ADDENDUM NO. 3

May 1, 2024

Blue River Valley Schools Renovations to:

Elementary School4713 Viking Trail
New Castle, IN 47362 **Jr. Sr. High School**4741 Viking Trail
New Castle, IN 47362

ES101

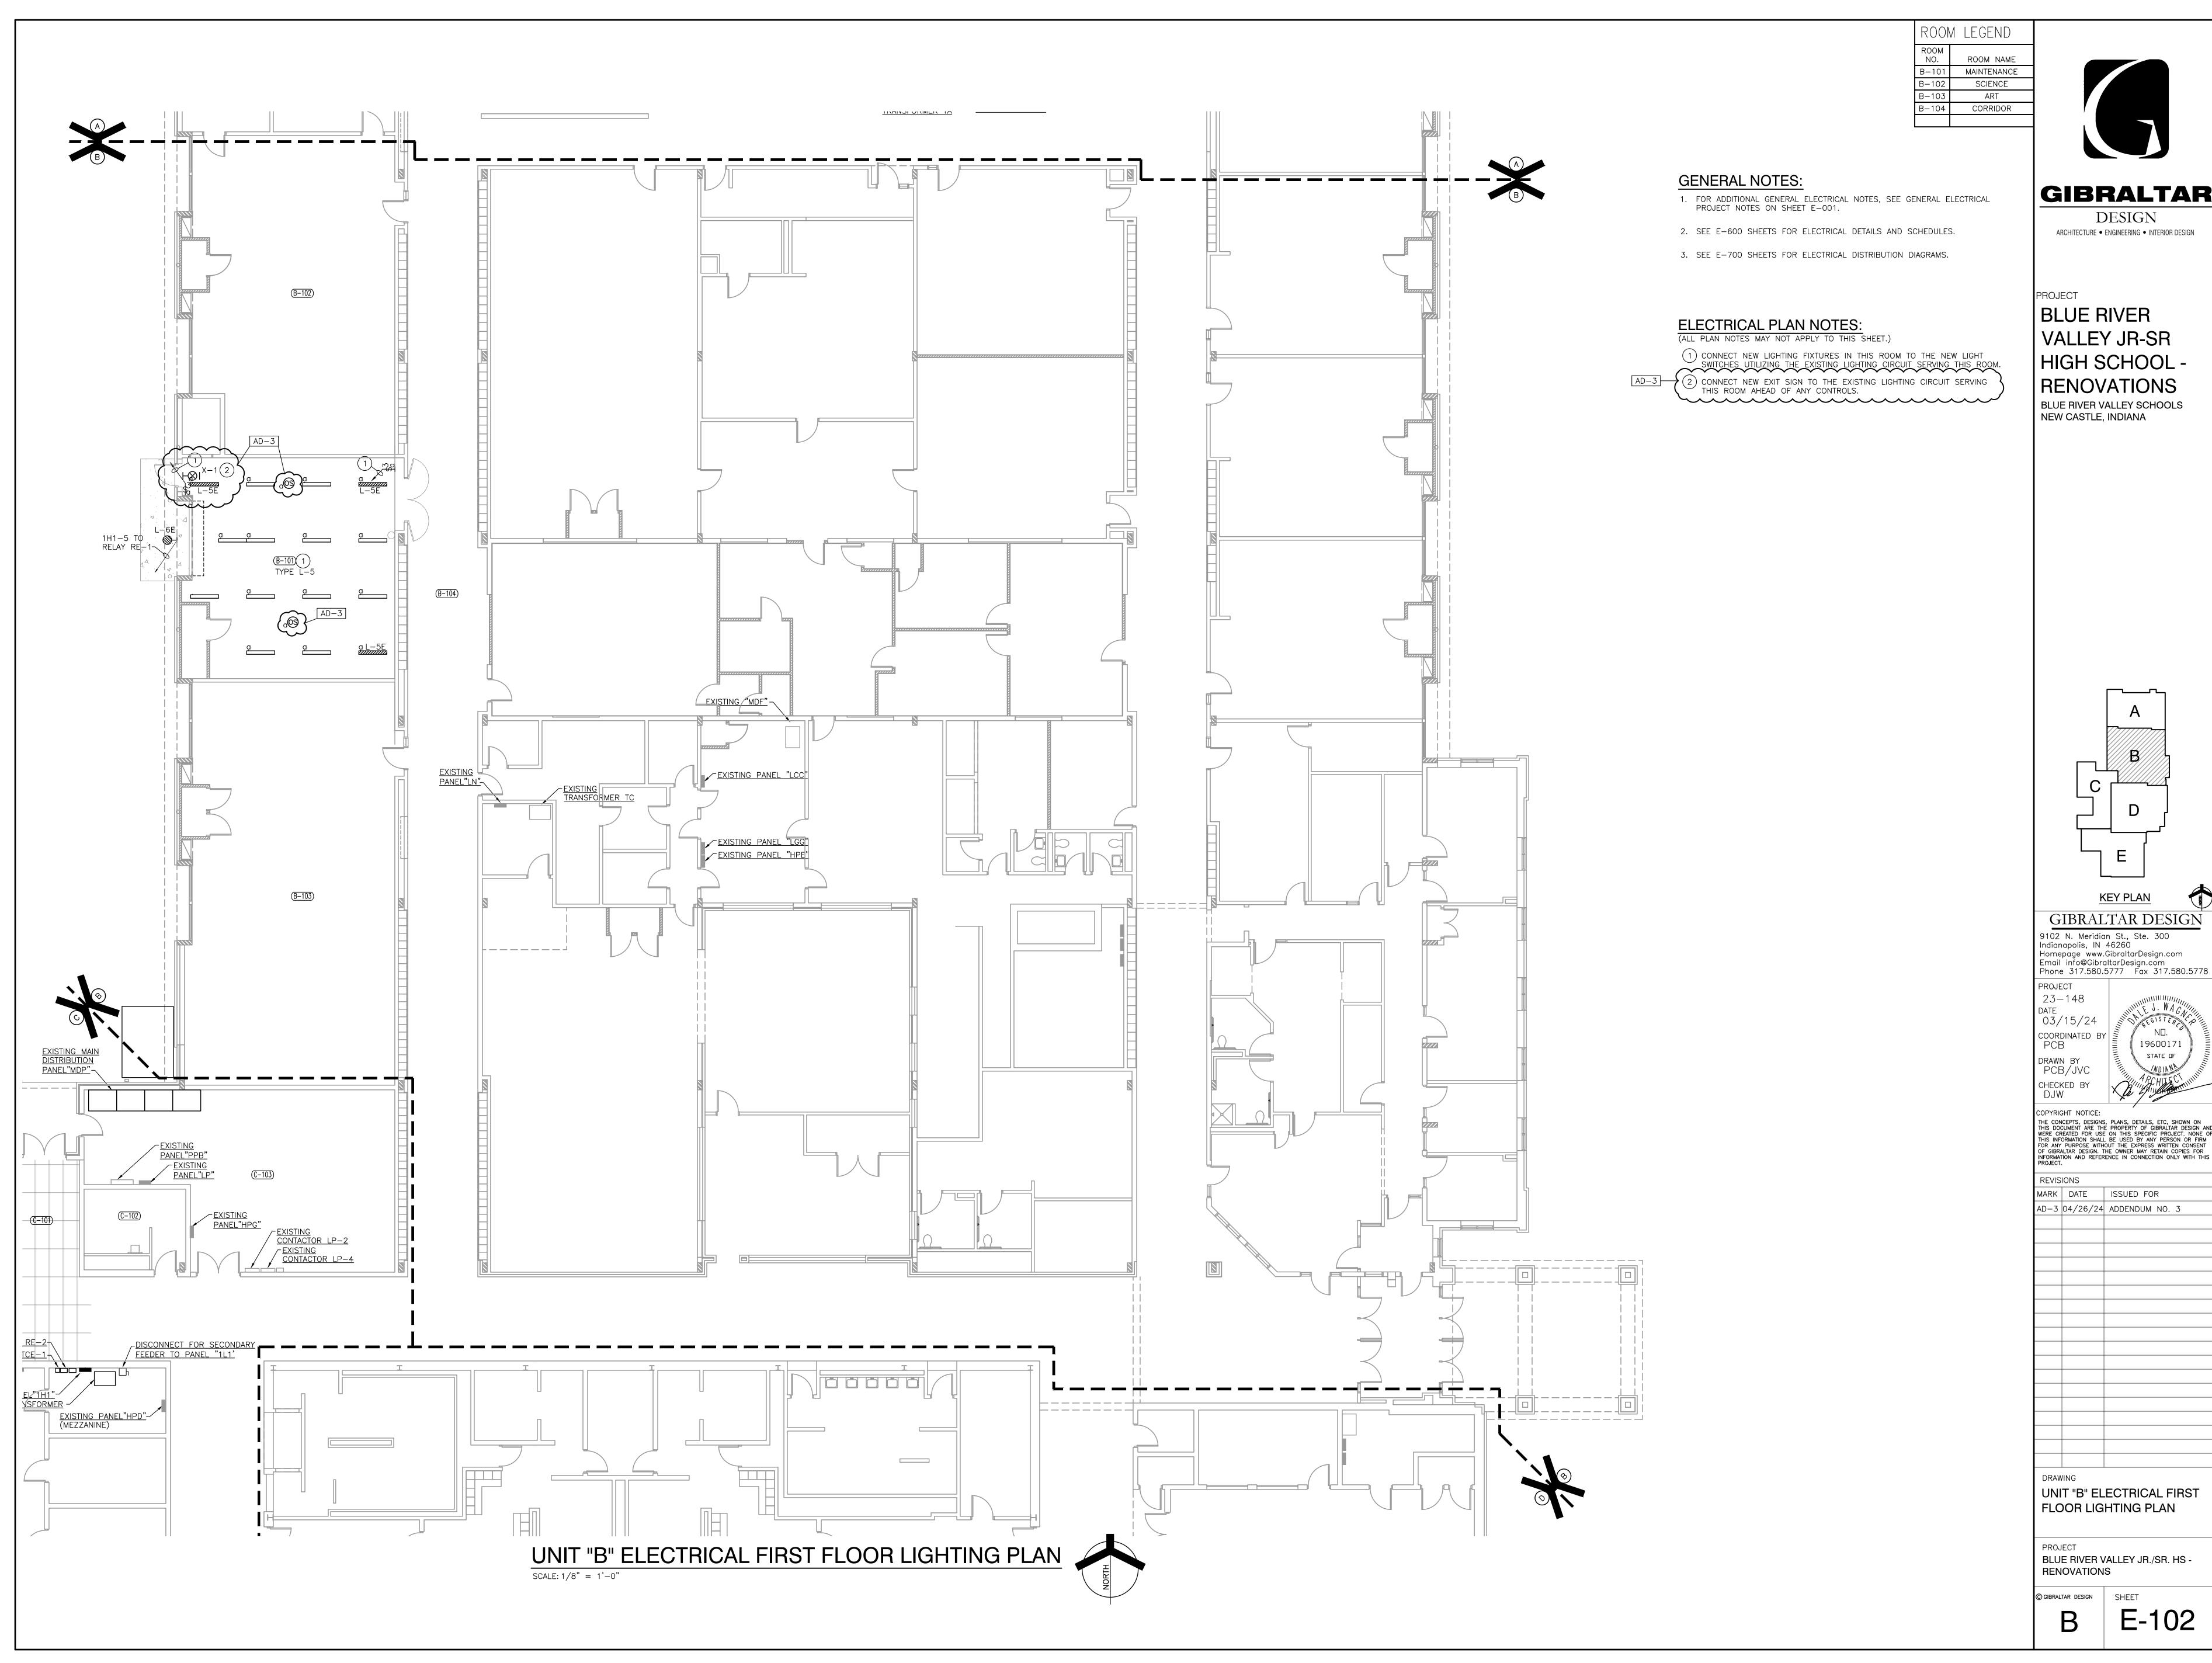
19. Sheet ES-101

- A. Refer to revised full size drawing included in this Addendum, which includes as a minimum the following revisions:
 - 1. Correcting Fixture Type for the Site Lighting Fixture.
 - 2. Modifying the routing of the feeders to the Maintenance Building.
 - 3. Clarifying the routing of the feeders/circuits to the Fuel Island.

DRAWING ELECTRICAL POWER DISTRIBUTION DIAGRAM

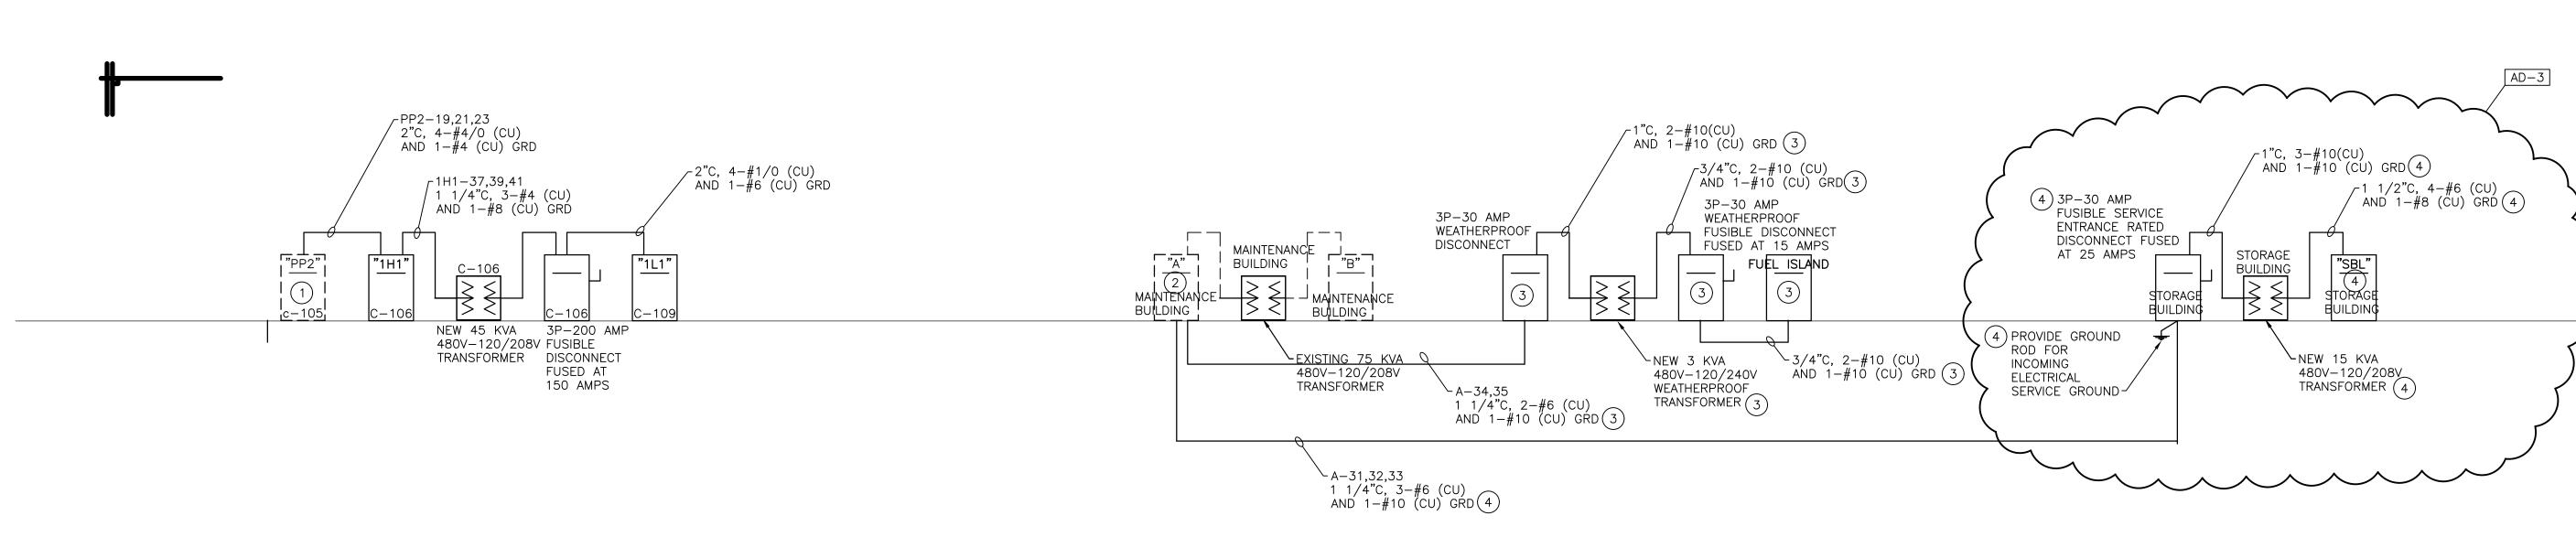
23. Sheet E-701

- A. Refer to revised full size sheet included in the Addendum for revisions, which includes as a minimum the following:
 - 1. Correcting a few plan notes on the drawings.
 - 2. Adding a ground rod at the New Storage Building.
